**FINAL
FACILITY-WIDE GROUNDWATER MONITORING PROGRAM PLAN
RVAAP-66 FACILITY-WIDE GROUNDWATER
ADDITIONAL WELL INSTALLATION ADDENDUM**

**RAVENNA ARMY AMMUNITION PLANT
RAVENNA, OHIO**

RE: RAVENNA ARMY AMMUNITION PLANT, PORTAGE/TRUMBULL COUNTIES, REGARDING RESP. TO COMMENTS ON DRAFT ADDITIONAL WELL INSTALLATION ADDENDUM, DATED MAY 24, 2013, OHIO EPA ID # 267-000859-036

RE: RAVENNA ARMY AMMUNITION PLANT
PORTAGE/TRUMBULL COUNTIES
NOTICE OF DEFICIENCY, DRAFT FWGWMP-
ADDITIONAL WELL INSTALLATION
ADDENDUM DATED MAY 24, 2013
OHIO EPA ID # 267-000859-036

SIZE	PROJECT NO.	DWG NO.	REV
D	030174.0016	FIGURE 1	0

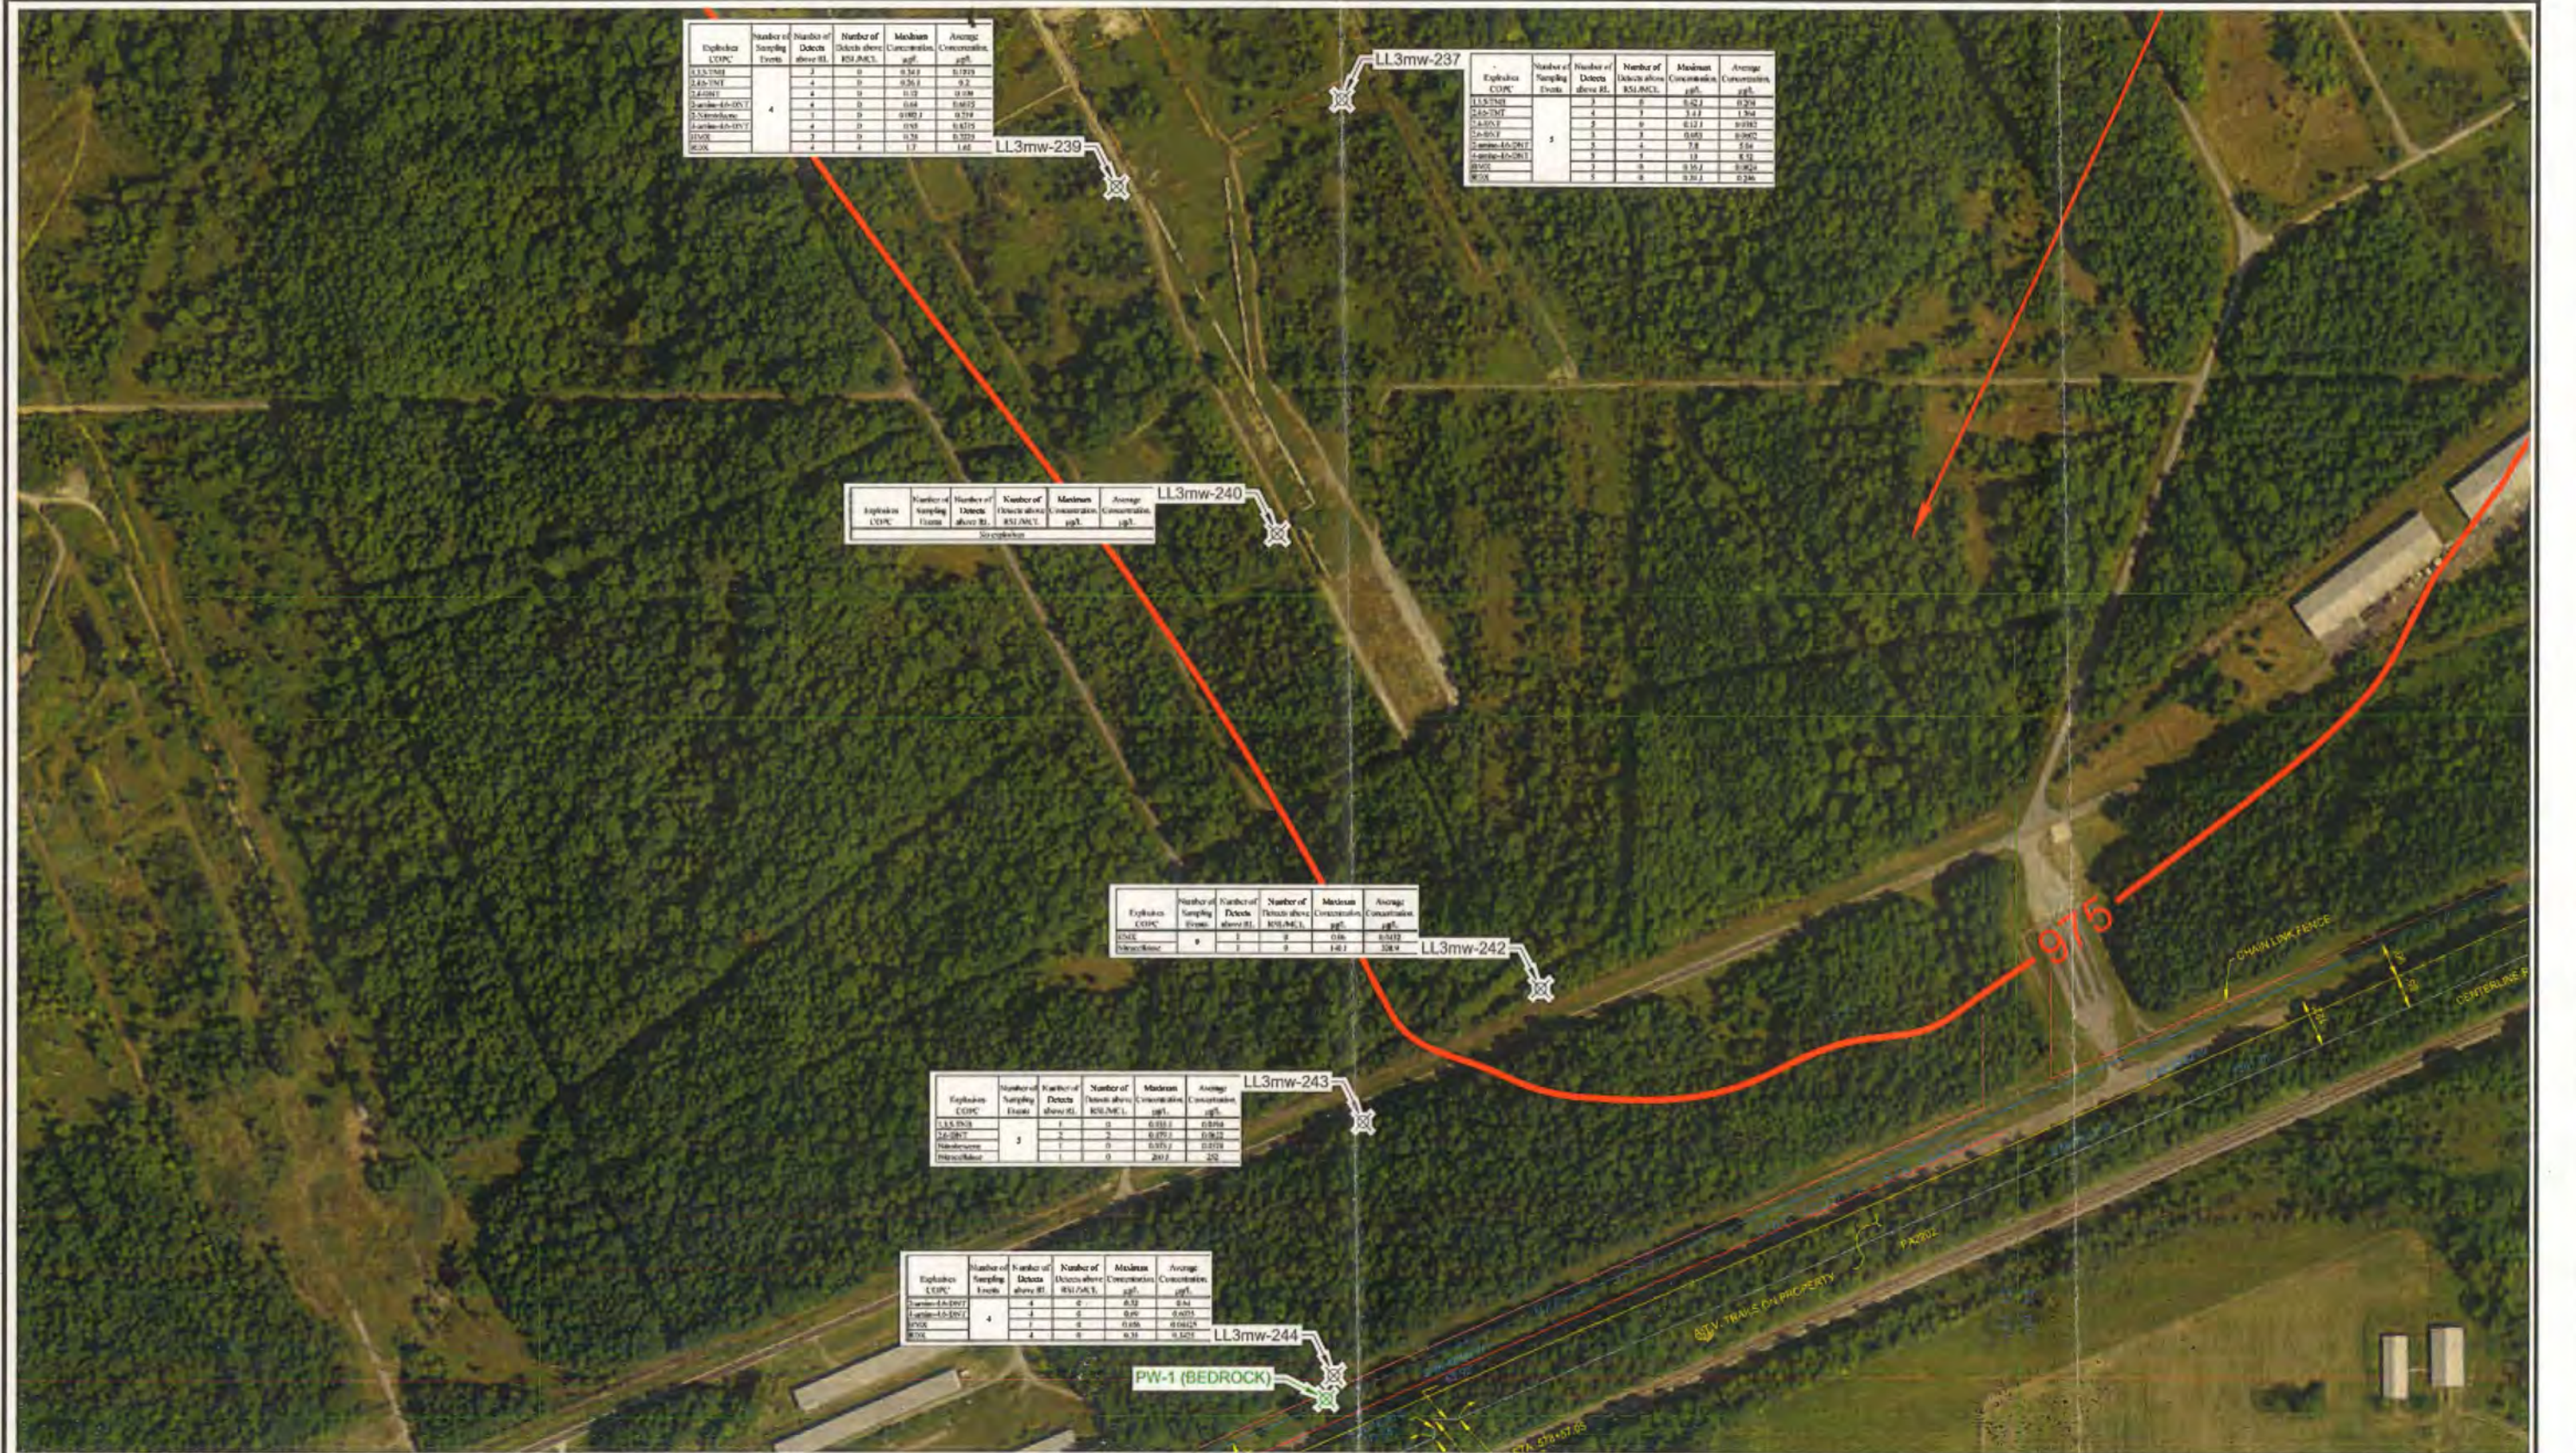
5. Figures 1, 2, and 3 do not provide any legend describing the well symbols and the significance of the one labeled existing monitoring well. Please revise the map accordingly and provide additional information as requested in comment 8.
6. The existing monitoring well in white on Figure 2 is mislabeled. It should be LL2mw-059.
7. The existing monitoring well in white on Figure 3 is mislabeled. It should be LL1mw-086.
8. Page 3, paragraph 1, states that the locations of well installations are based on the existing potentiometric surface maps for the facility, preliminary fate-and-transport

5. Figures 1, 2, and 3 do not provide any legend describing the well symbols and the significance of the one labeled existing monitoring well. Please revise the map accordingly and provide additional information as requested in comment 8.

8. Page 3, paragraph 1, states that the locations of well installations are based on the existing potentiometric surface maps for the facility, preliminary fate-and-transport model outputs, and facility right-of-way maps. Figures 1, 2 and 3 should provide the information on which these decisions were made. For example, please provide a few potentiometric surface contour lines associated with the areas of concern from the units affected (it is assumed the most recent maps were used). Provide some generalized information from the fate and transport model that supports decisions to place wells in these areas. Provide the locations of two or three monitoring wells, not just one, that show contaminants of concern upgradient of the proposed wells.

Response: *The figures will be revised to include this information.*

Response: *The figures will be revised to include this information.*

SIZE	PROJECT NO.	DWG NO.	REV
D	030174.0016	FIGURE 2	0

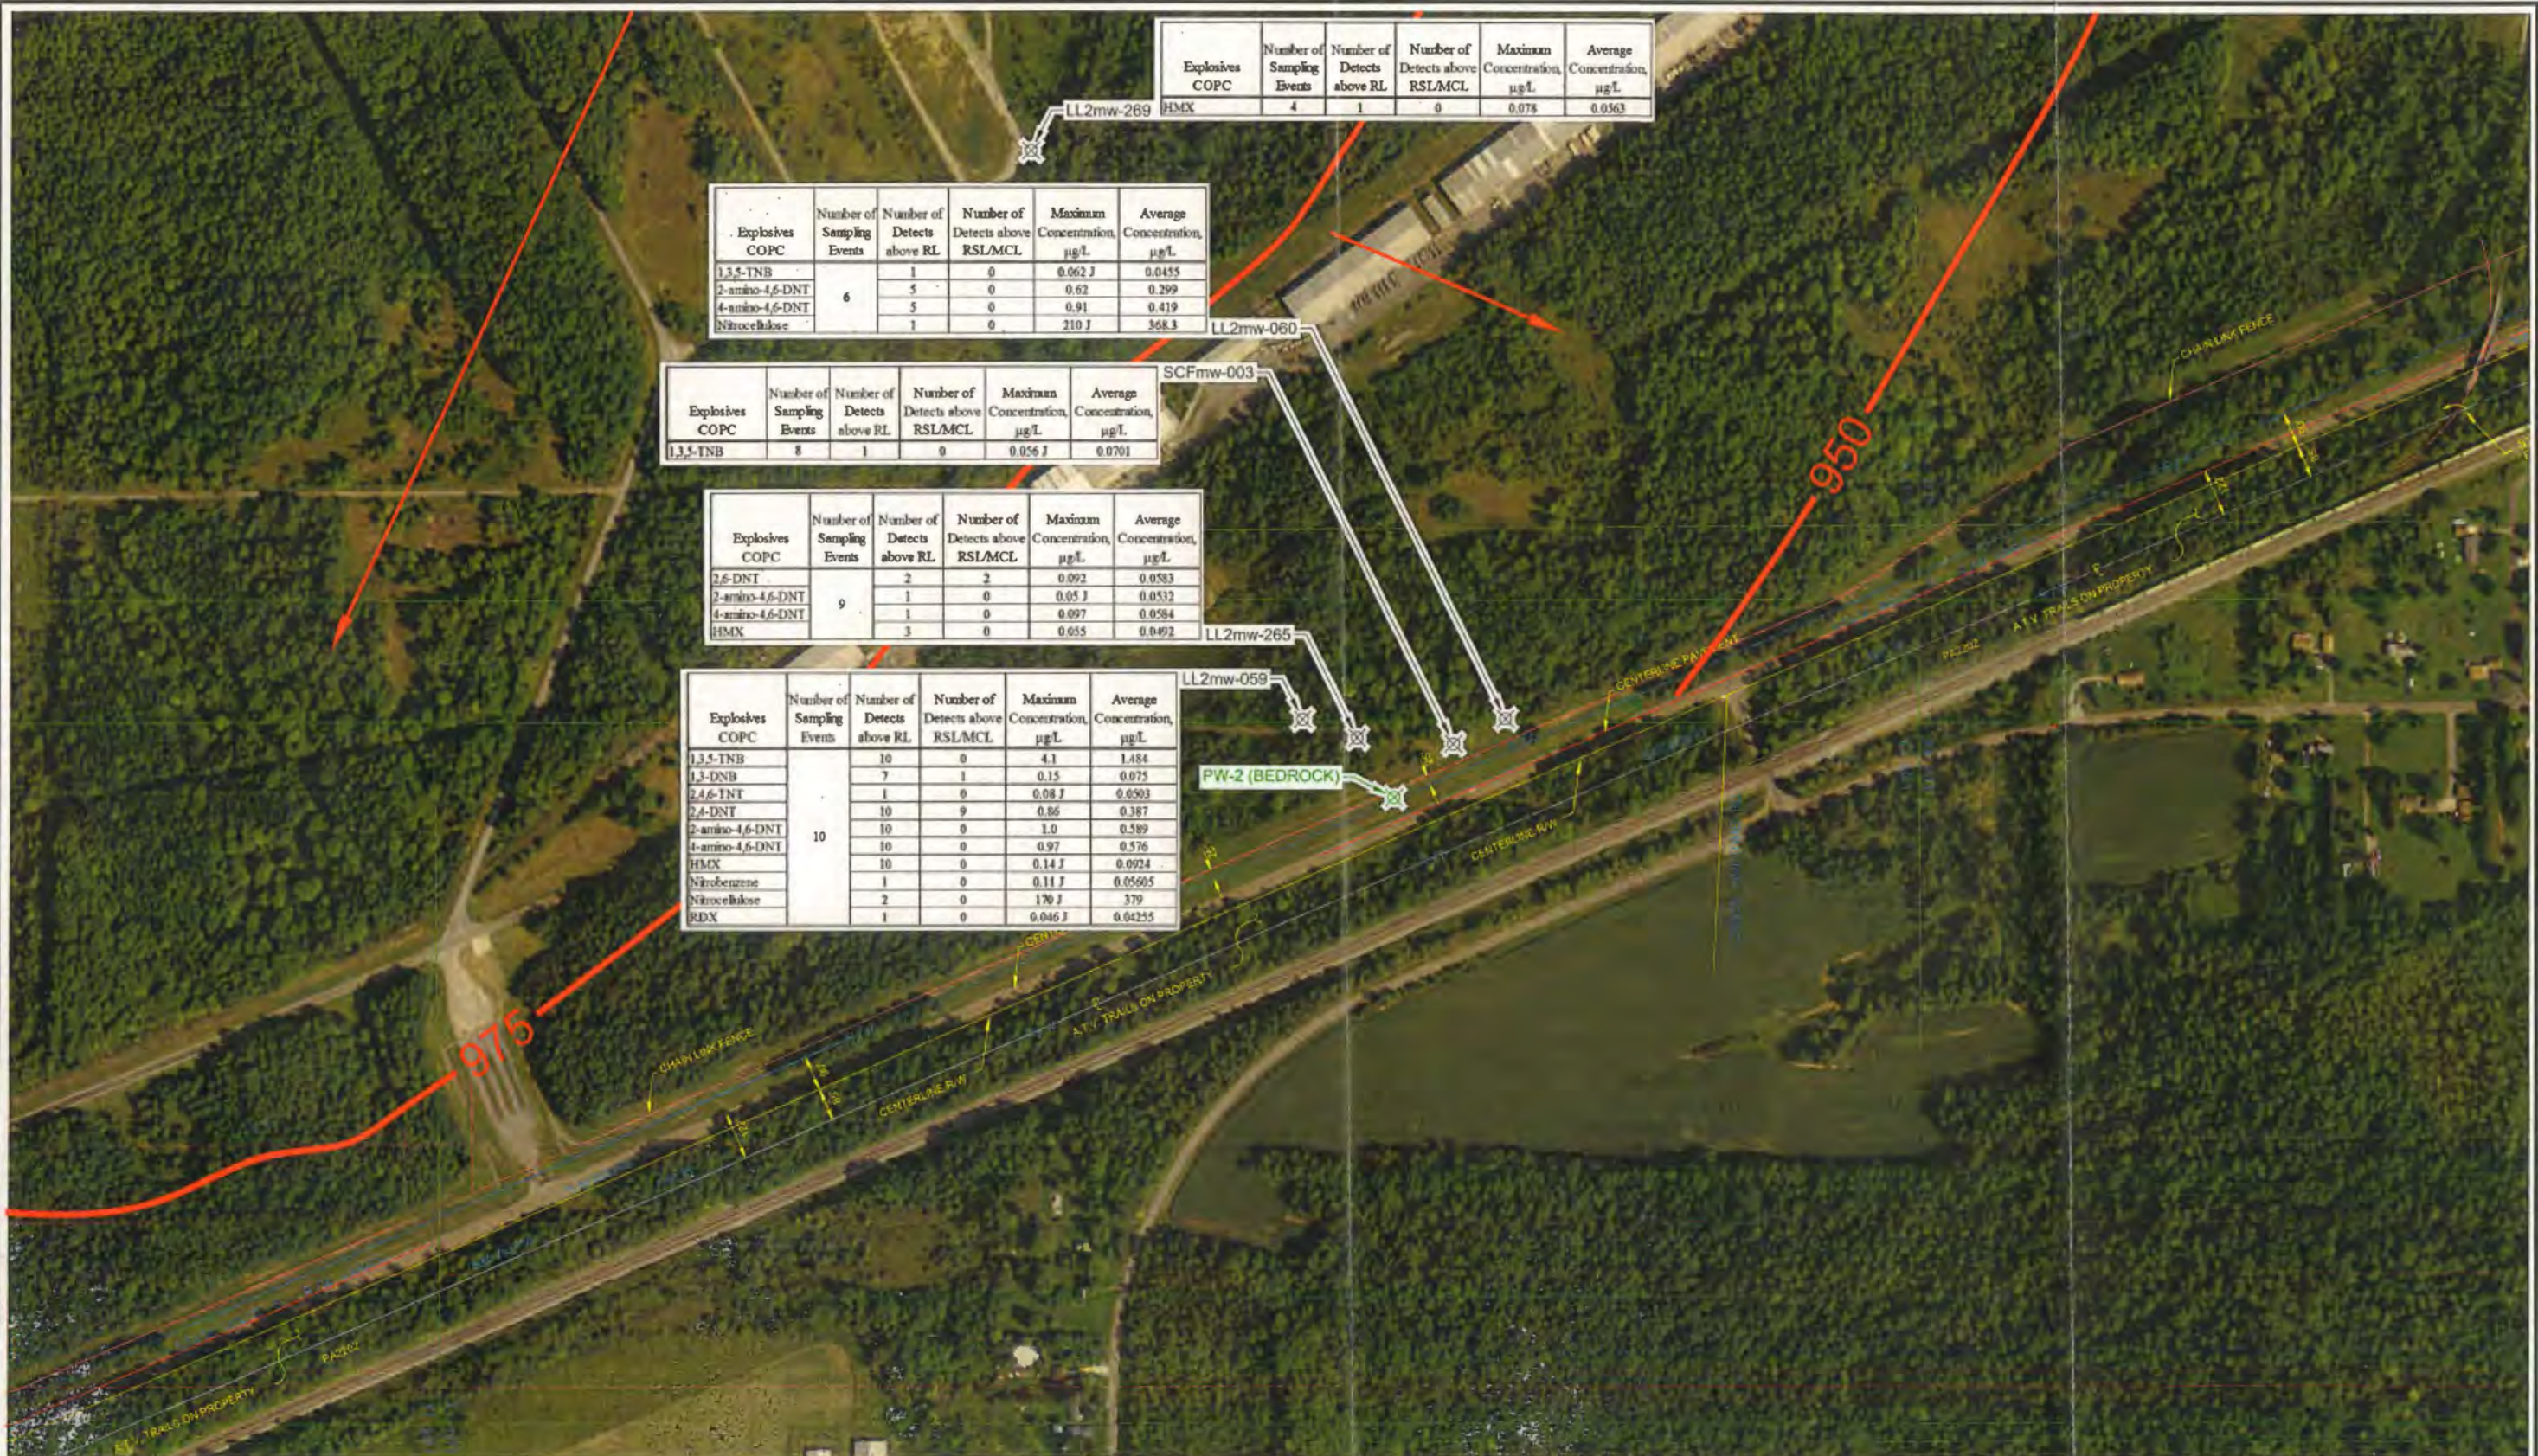
6. The existing monitoring well in white on Figure 2 is mislabeled. It should be LL2mw-059.

Response: *We will make this correction.*
